K3 KIT ASSEMBLY MANUAL ERRATA

Rev. L3-3, January 18, 2011

Figure 1. Mounting VFO A Trim Panel.

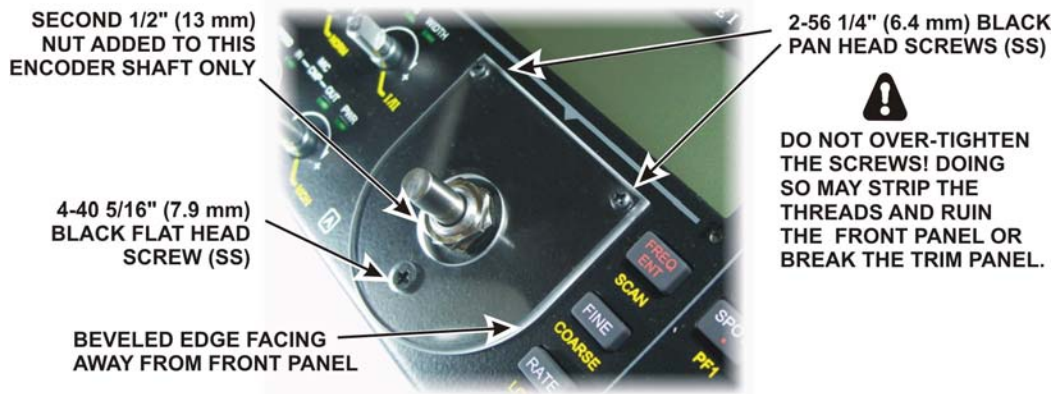
1. **Page 33, first step:** Replace the step and Figure 44 below it with the following. You can cut out the new step and figure and paste them over the existing step and figure in the manual:

Brush or blow any dust or lint away from the front panel area around the encoder shaft under the LCD, then mount the trim panel as shown in Figure 44, oriented so the beveled edges are away from the front panel. Use the 2-56 1/4" screws and the 4-40 5/16" screw found in the small envelope marked E850341 VFO A Bezel Screws Envelope. Tighten the screws only until they come into firm contact with the trim panel. (If you had already opened the envelope, be sure you are using the 1/4" (6.4 mm) screws and not the shorter 5/32" (4.0 mm) screws.) ***Be careful not to over-tighten the screws or you may strip the threads or break the trim panel!***
